# 45 New Street Inglewood H-GO Proposal

Response from Inglewood Community  
Members

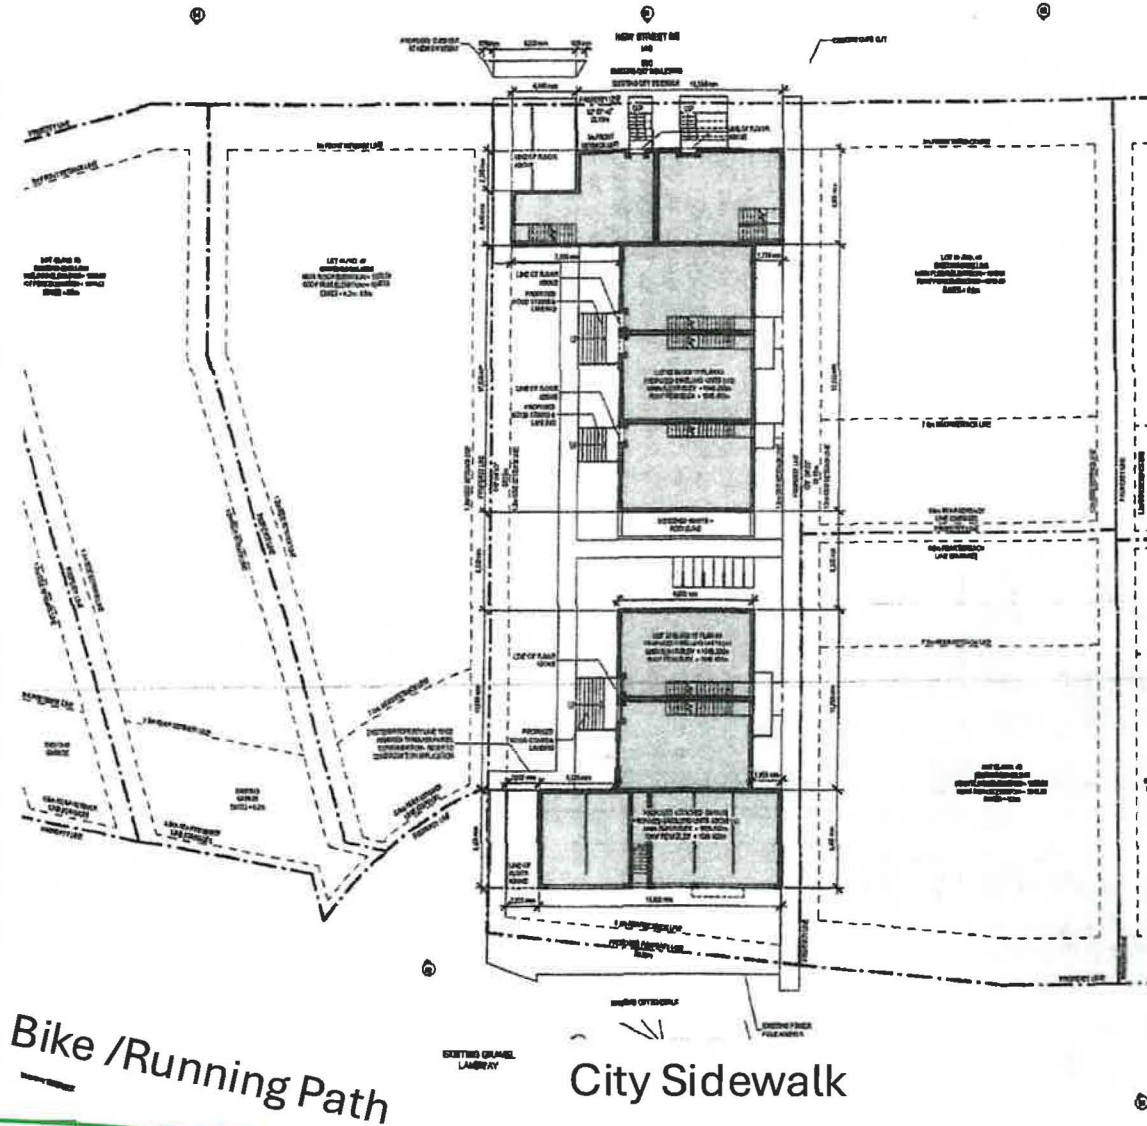
**Non-Compliance Issue:**  
Proposed Units are 2X ARP maximum for H-GO development.

**Non-Compliance Issue:**  
Proposed Units are not end-of-block as recommended for H-GO development

**Safety Issues:** Proximity of 6 Parking Garages to Sidewalk, unfenced Nellie Breen Park, busy pathway with uncontrolled crossing, lack of traffic calming & power pole anchors

**Non-Compliance and Insensitive Design Issue**  
Proposed Development has significant shading and view over neighbors back yards

**Safety Issue:** No Firewalls in Units in tight development and close neighbors.

**Safety Issue:** Vehicles Backing out by Power Poles and Anchors

**Parking Issues:** Adds significant parking demand to already constrained area

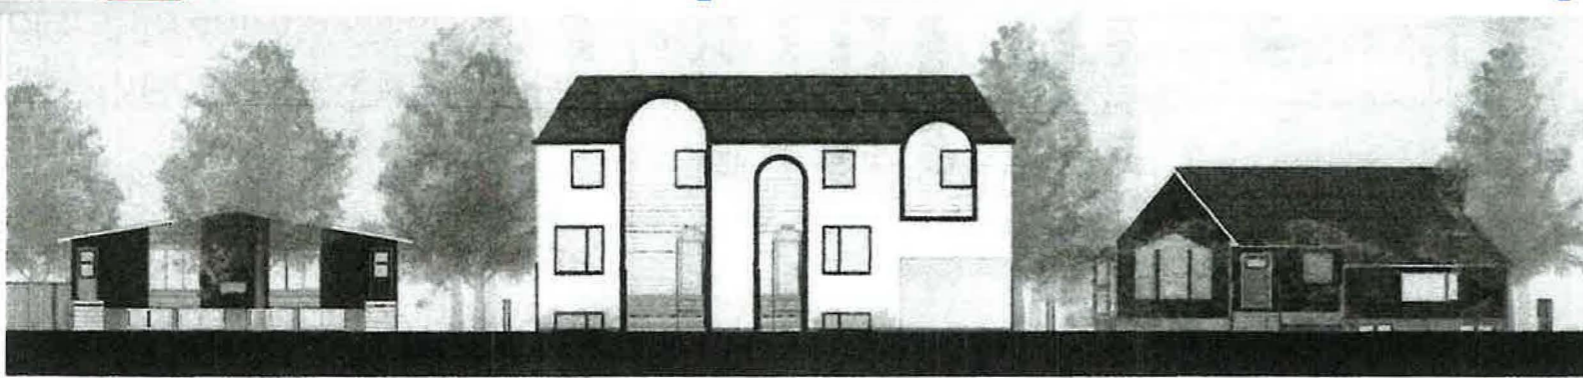
**Community Engagement Issue:**  
Neighbors opinions not sufficiently collected and documented

**Community Character Issue:**  
Single Building Mass out of character with neighborhood

**Parking Issues:** Adds significant parking demand to already constrained area on narrow street (New Street)

**Safety Issues:** New Street popular commuter recreational bike/scooter usage on a narrow road with existing parking issues

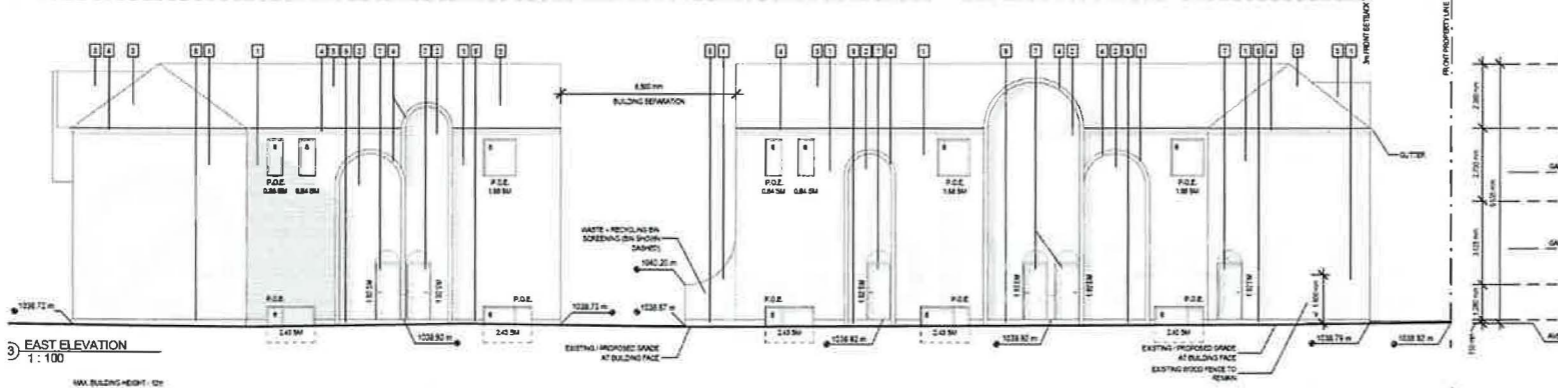
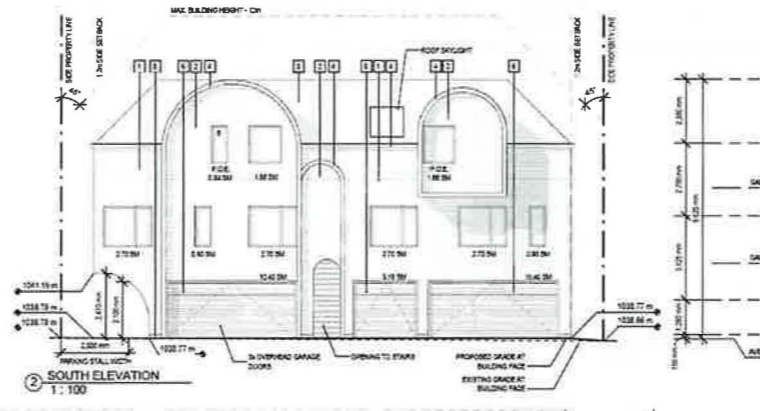
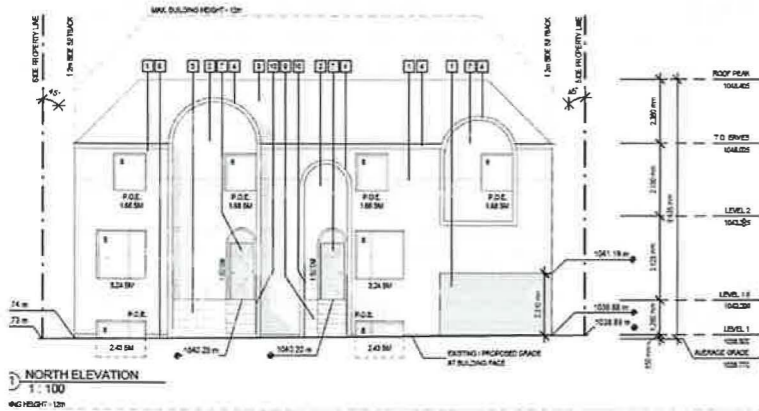
**Safety Issues:** Electric Bike parking between non-firewalled buildings potential hazard

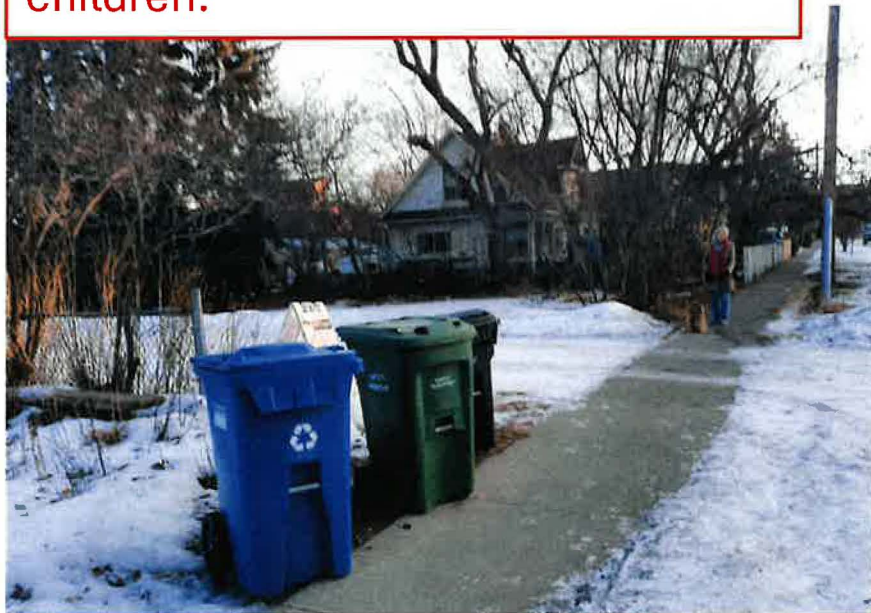
Adding up to 32 bins on combined blue/green cart days adds safety(and traffic) concerns. Drivers backing out will have to navigate power pole, sidewalk, pathway, roadway, and Nellie Breen Activity where bins are taller than most children.

New Street is a very narrow road, that is already quite busy/congested with a lot of bike and scooter traffic

Lack of Firewalls in this high density of an area with the addition of bike storage beside the buildings poses threat to residents and neighbors

Electrical Pole anchors where cars will be backing out across sidewalk, pathway, etc.
